Carroll, Iowa

TRAFFIC SAFETY STUDY

HENNINGSON, DURHAM & RICHARDSON

PRELIMINARY

figure 2

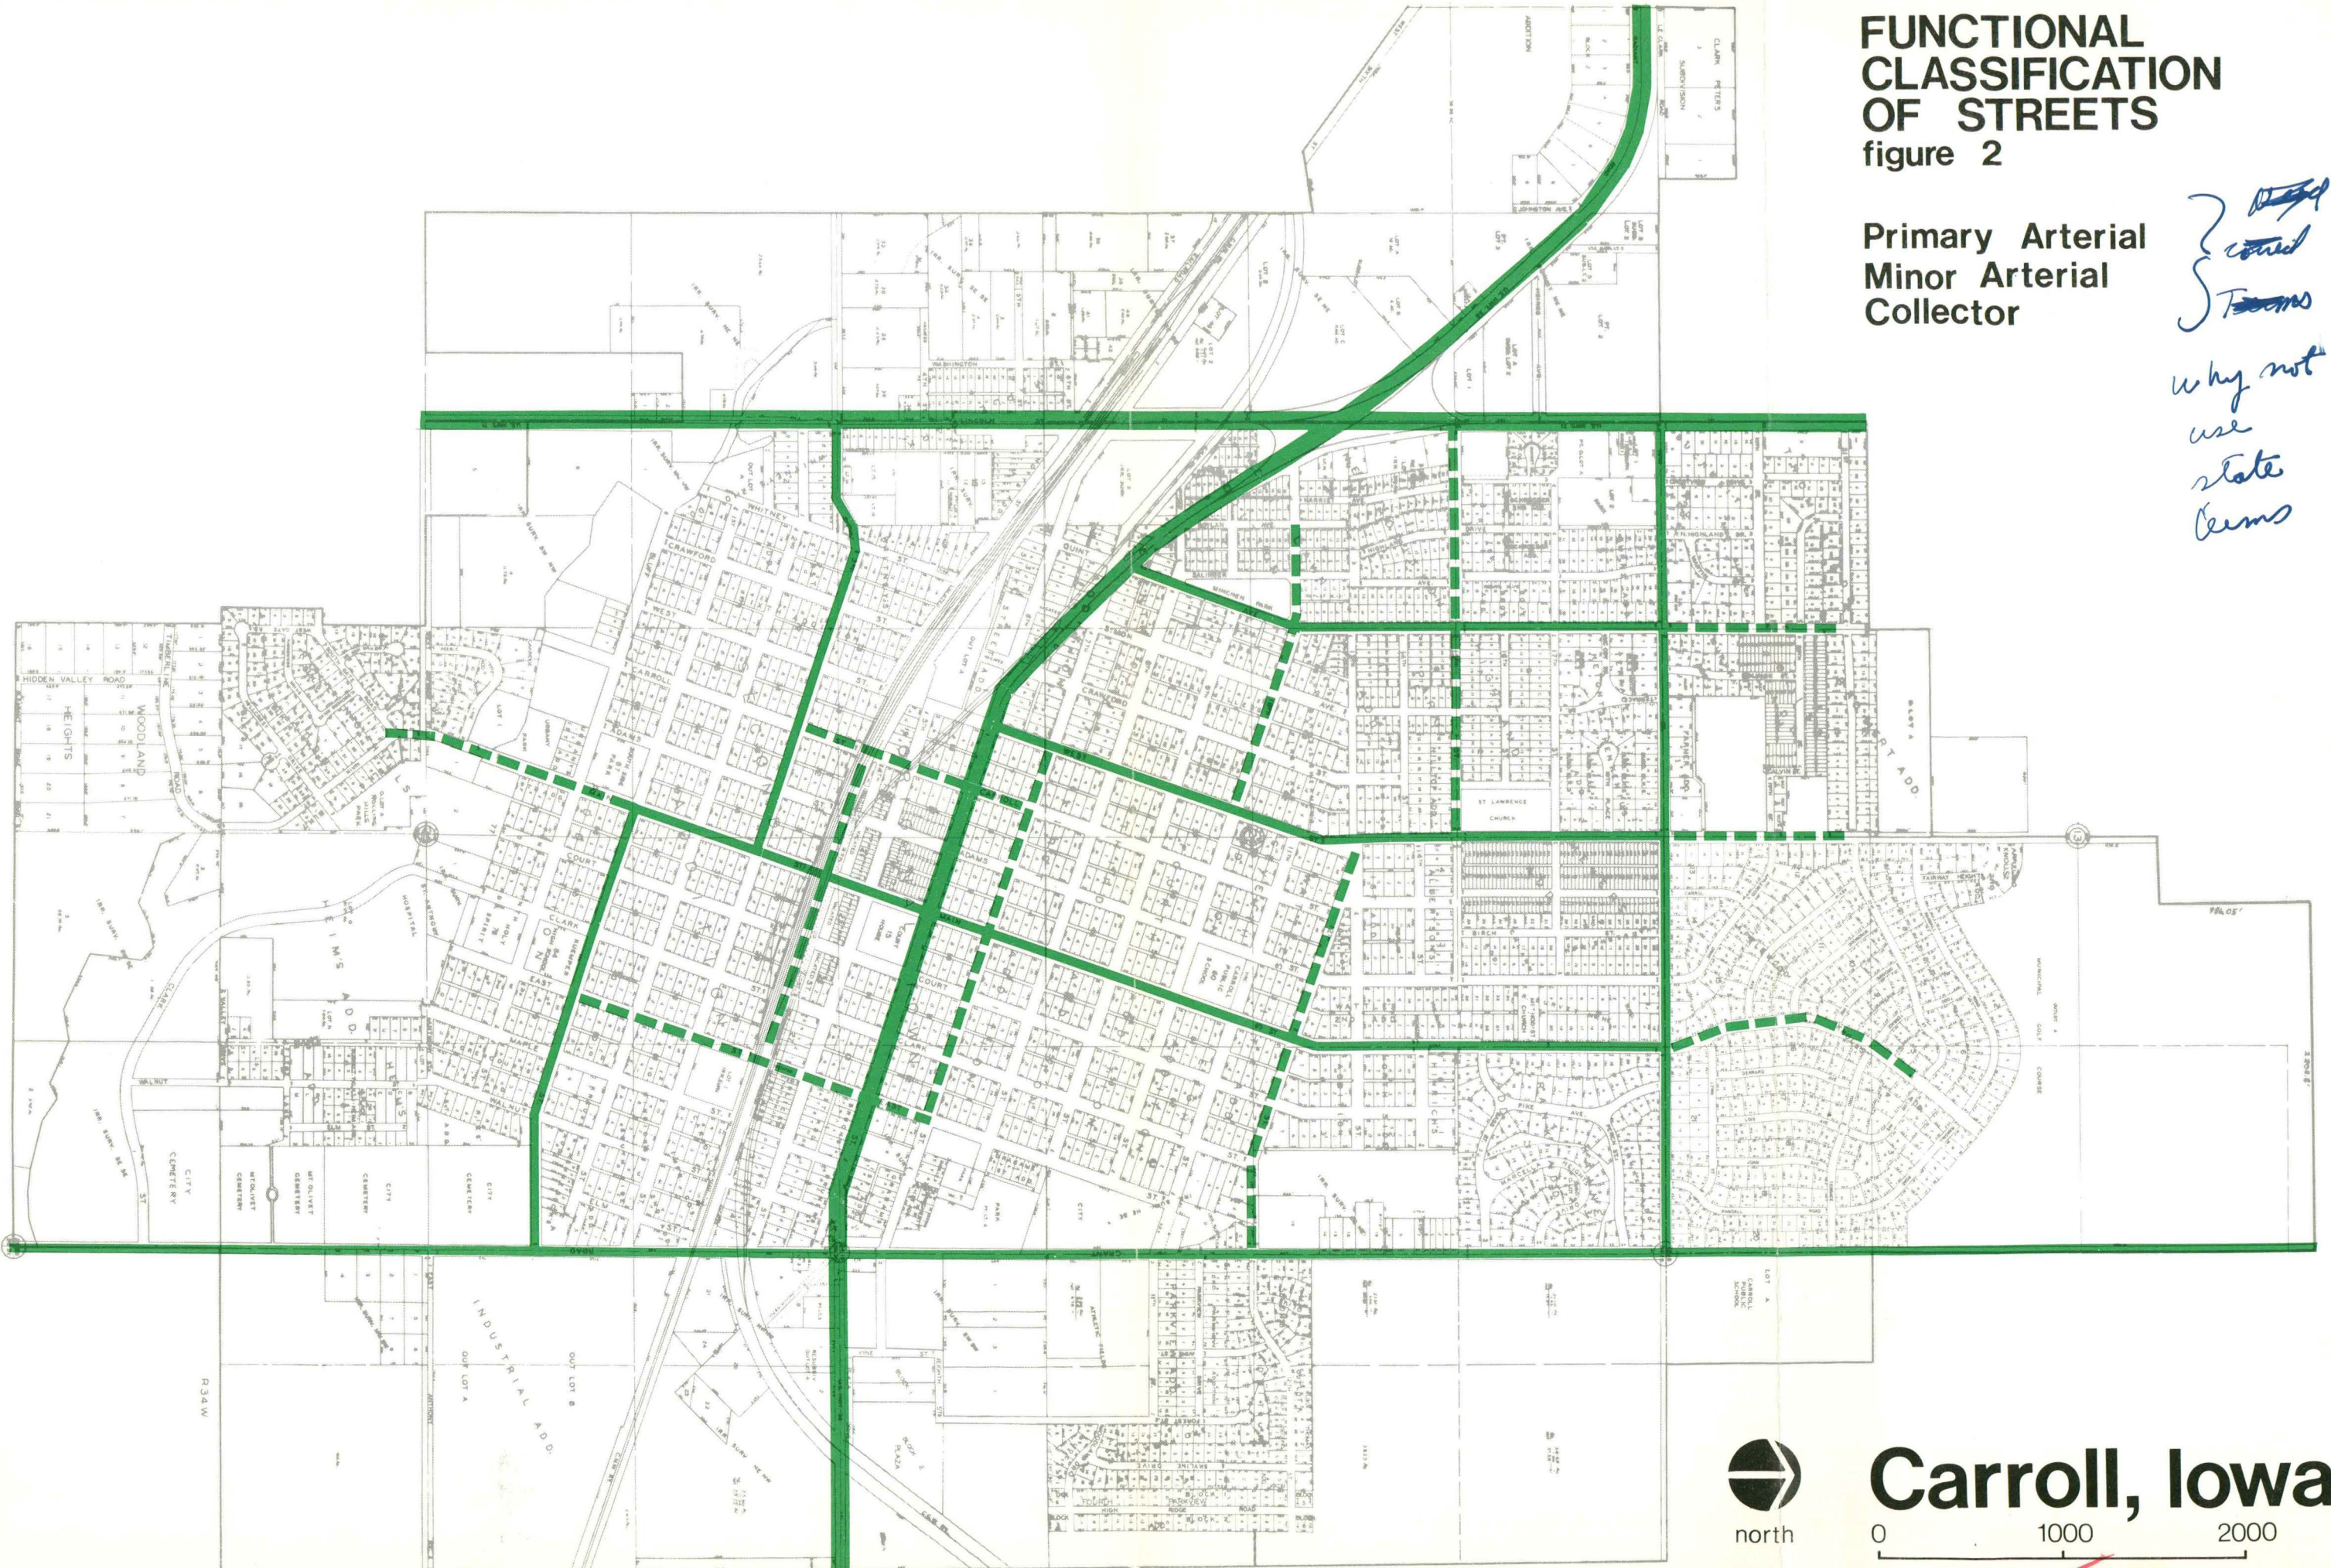
why not use state terms

FEDERAL AID SYSTEM figure 3

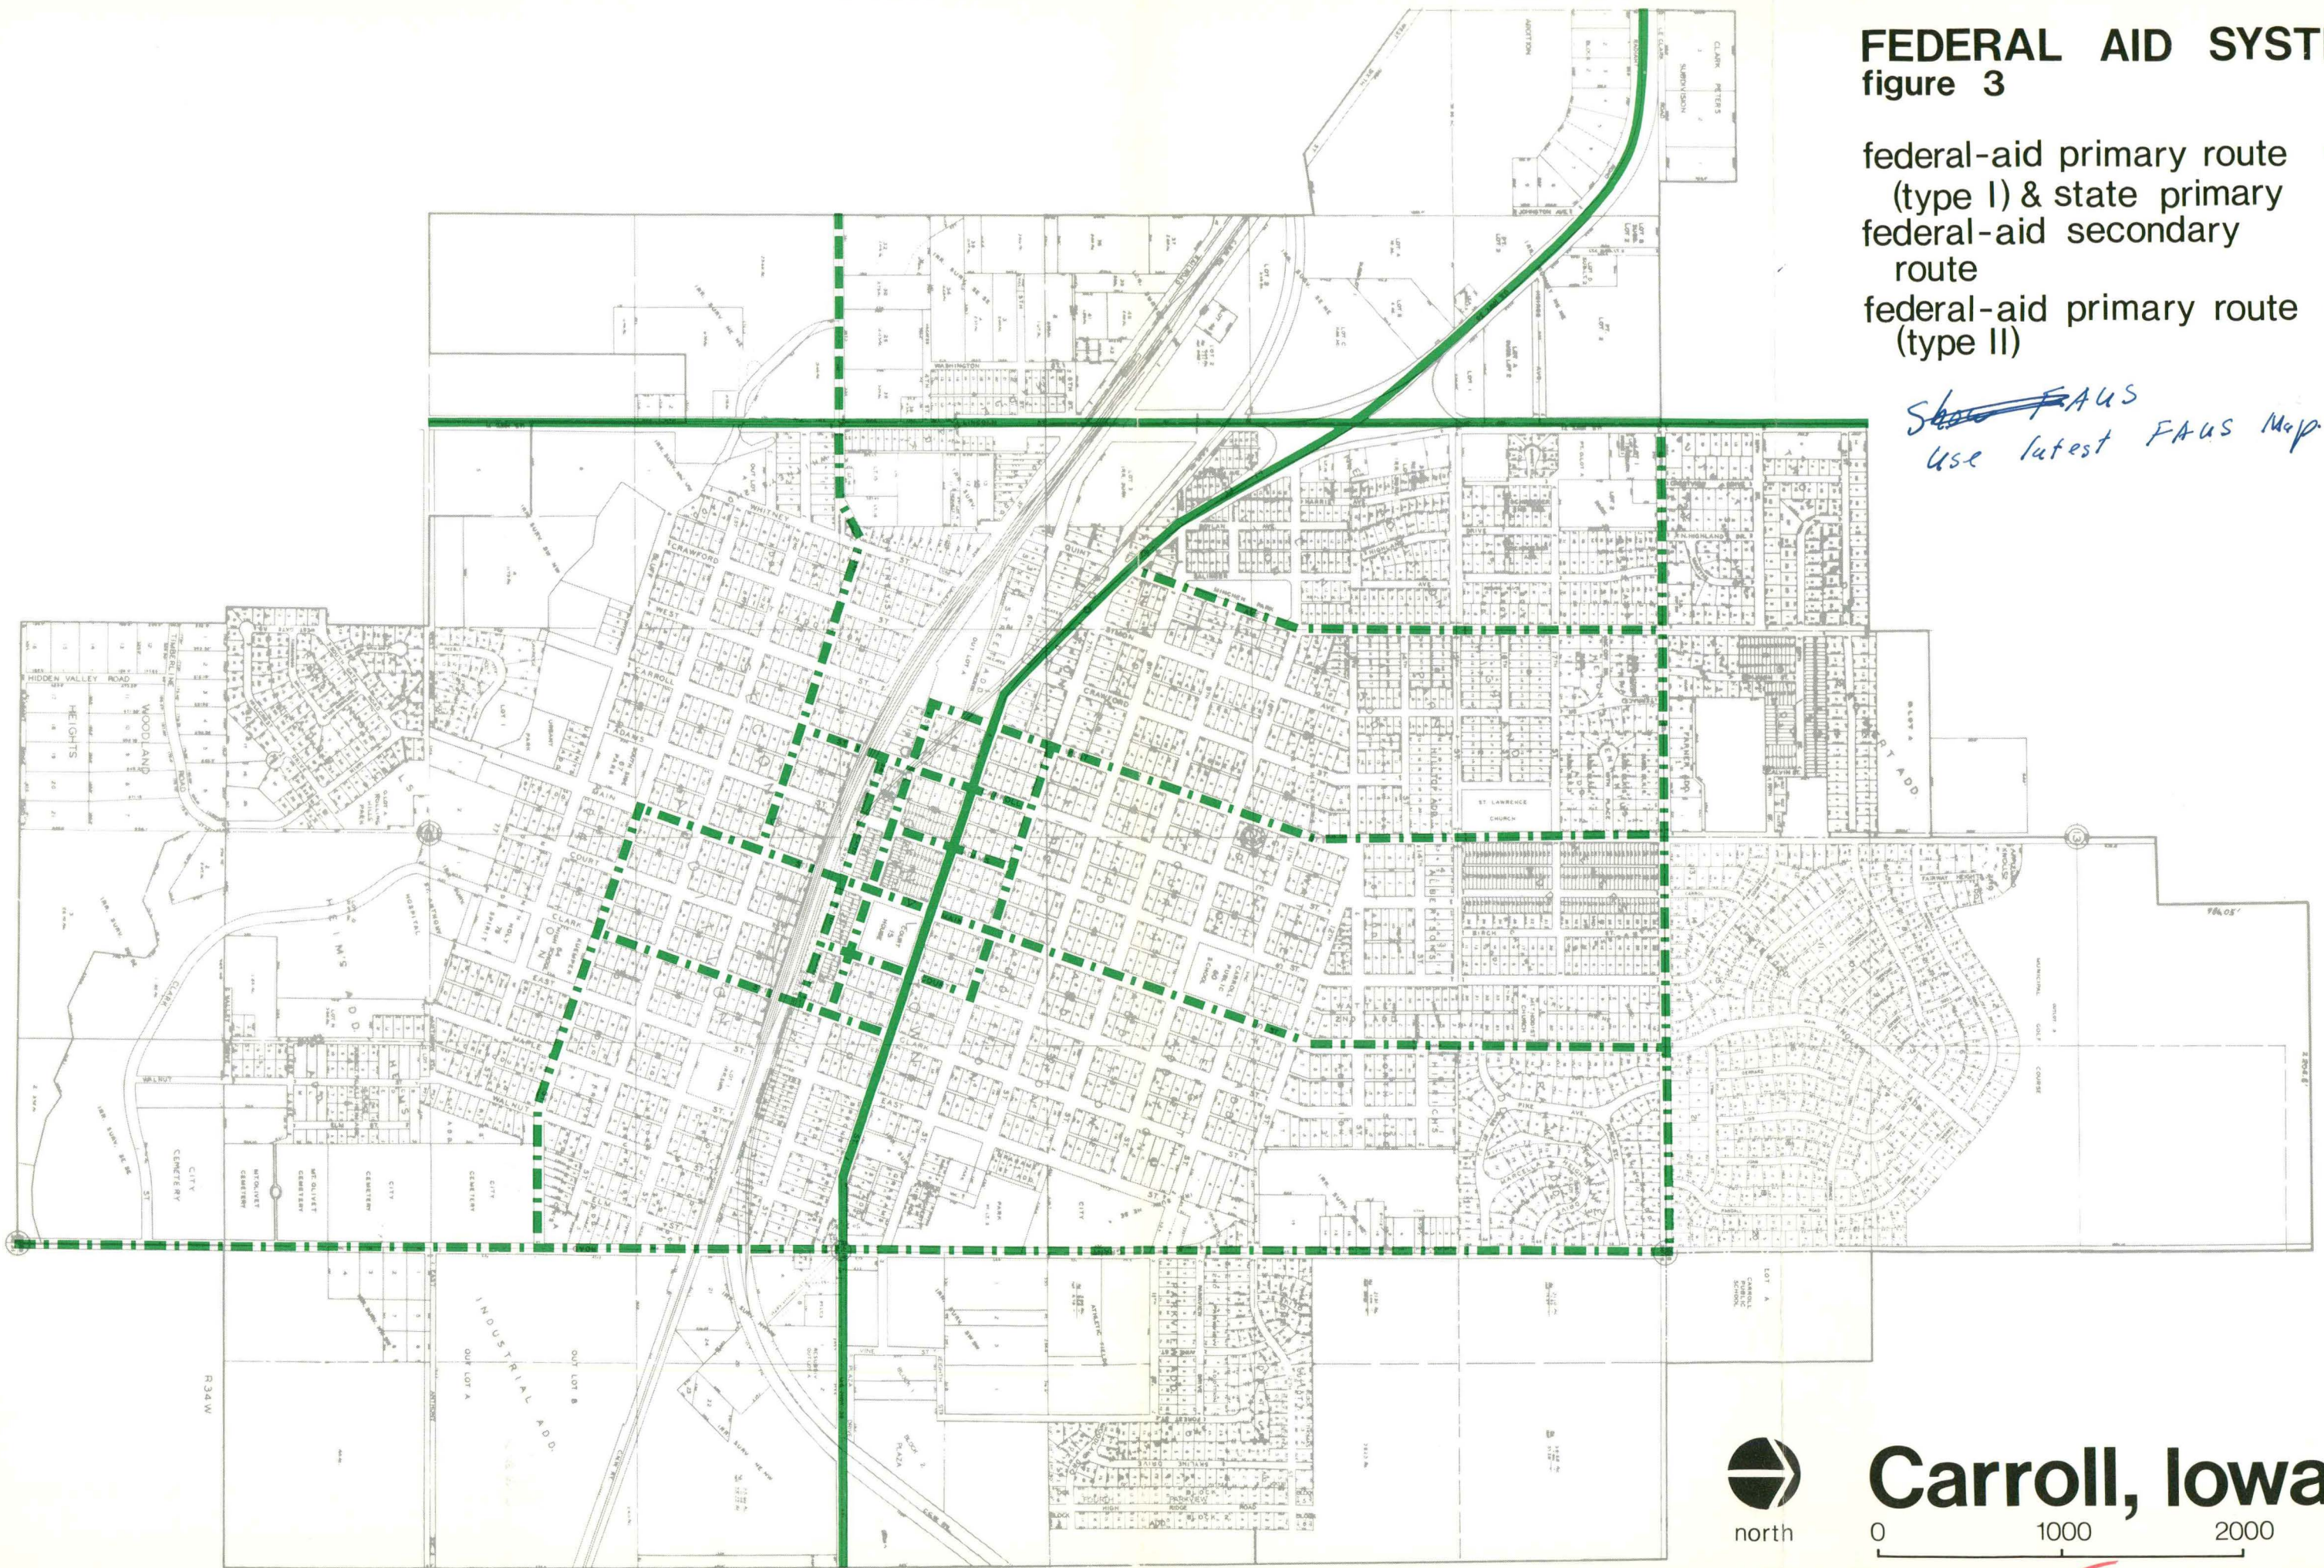
*Show FAUS
Use latest FAUS Map*

figure 6

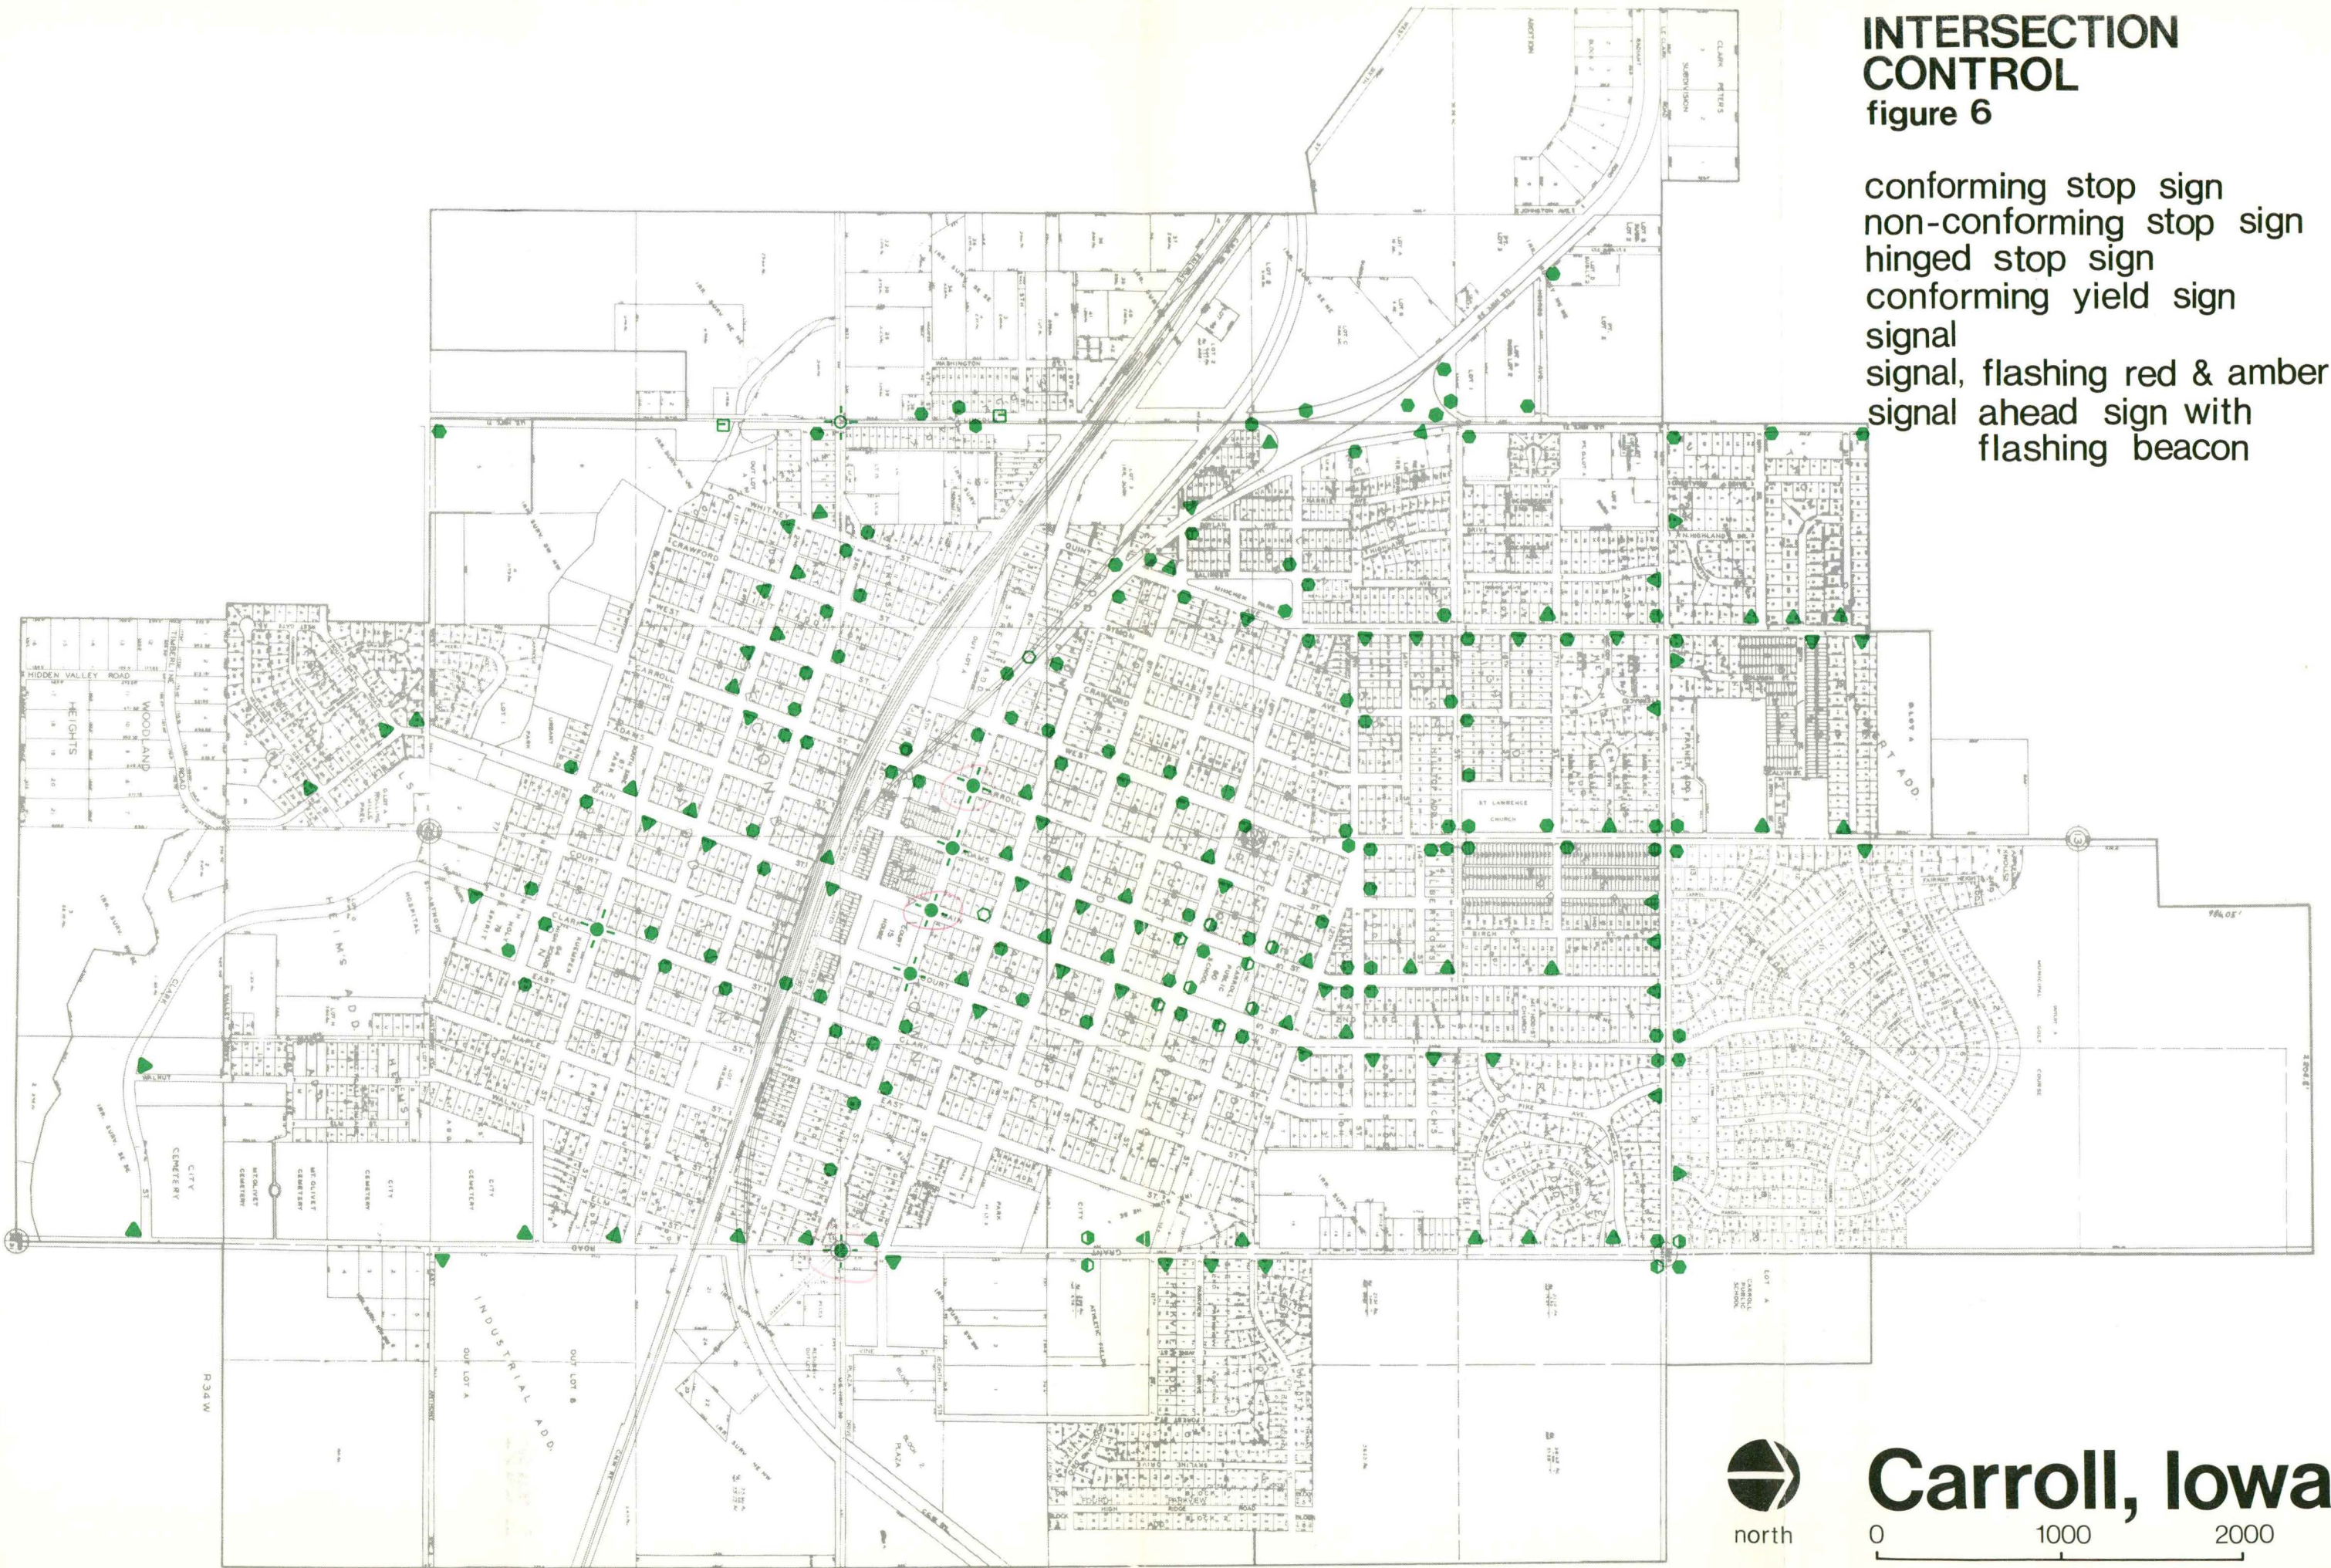
I would like to see a time/space diagram of the signal installations along U.S. 30 to see if the system does indeed operate "very efficiently" or if perhaps it could be modified to allow a more reasonable progression than seems apparent in Carroll.
